6692A-04

S E R V I C E N O T E

6692A DC System Power Supply

Potential Installation fault to users when the AC line cord is connected to the AC fuse holder/line cord module p/n 2110-1312.

Figure 1

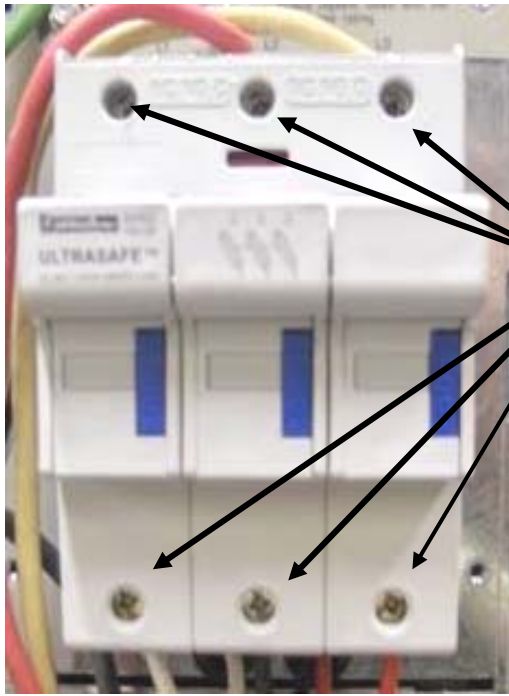
The fault is with respect to the AC line cord connection. If the screw terminals on the AC fuse holder/line cord module are not clamped down using the specified torque of 35 inch-pounds, (4 Newton-meters) then a wire of the AC line power cord may slide out of the AC fuse holder/line cord module. This could allow an AC line cord conductor to come loose and possibly touch another terminal or the chassis. That, in turn could potentially cause damage to the AC fuse holder/line cord module, the instruments chassis or the wiring. (See figure 1)

When connecting the AC line cord to the AC fuse holder/line cord module, you must use a torque of 35 inch-pounds (4 Newton-meters) on the screws. See Figure 1

The six (6) clamp screws indicated must have 35 inch-pounds (4 Newton-meters) of torque to firmly secure the AC conductors. This ensures adequate mechanical pressure

To check if the line cord is properly clamped, use a torque driver with the proper tip and set the torque to 35 inch-pounds (4 Newton-meters). Loosen each of the 6 (six) screw clamps shown in Figure 2 and then retighten to 35 inch-pounds (4 Newton-meters) After each screw clamp is properly torqued to 35 inch-pounds, (4 Newton-meters) perform a wire-pull check to ensure the clamp is properly working and that the wire is secure. You should pull the wire in the vertical direction only and with enough force to give the confidence that the wire is clamped securely and cannot pull out. If the wire is secure, then your AC fuse holder/line cord module is not defective and your 6692A will work without fault.

If, after applying 35 inch-pounds of torque, (4 Newton-meters) you are able to pull out the wire, then you have a defective AC fuse holder/line cord module.

After you have applied the proper torque to each terminal, and have verified that each wire is held tight, re-install the AC safety cover, as shown in Figure 2
